# AIRWORTHINESS DIRECTIVE

CF-2023-49

Navigation – Rotorcraft – Prohibition of Operations Requiring Radio Altimeter When Operating in the Contiguous United States due to 5G C-Band Wireless Broadband Interference

Supersedes AD CF-2021-53, issued 24 December 2021.

**Figure 1 – Fundamental Effective Isotropic PSD at Outside Interface of Rotorcraft Antenna**

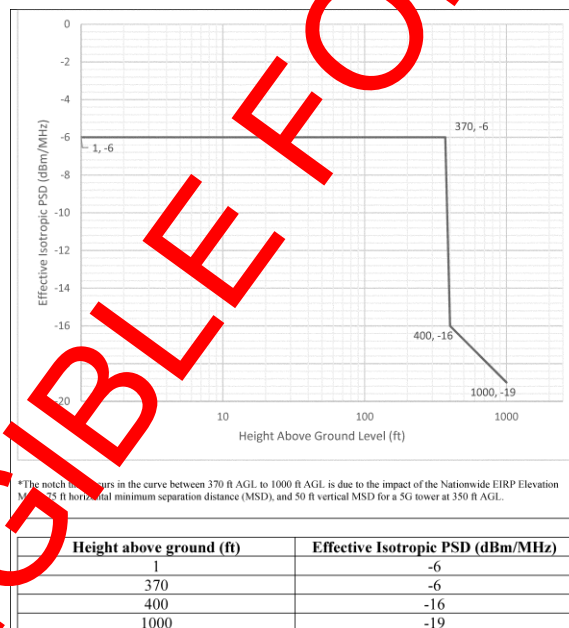
- A. A **radio altimeter tolerant rotorcraft** is one for which the radio altimeter, as installed, demonstrates the tolerances specified in Part I paragraphs A.1. and A.2. of this AD, using a method approved by Transport Canada or the FAA. No actions are required by this AD for radio altimeter tolerant rotorcraft.
1. Tolerance to radio altimeter interference, for the fundamental emissions (3.7-3.98 GHz), at or above the power spectral density (PSD) curve threshold specified in Figure 1 of this AD.
  2. Tolerance to radio altimeter interference, for the spurious emissions (4.2-4.4 GHz), at or above the PSD curve threshold specified in Figure 2 of this AD.
- B. A **non-radio altimeter tolerant rotorcraft** is one for which the radio altimeter, as installed, does not demonstrate the tolerances specified in Part I paragraphs A.1. and A.2. of this AD.
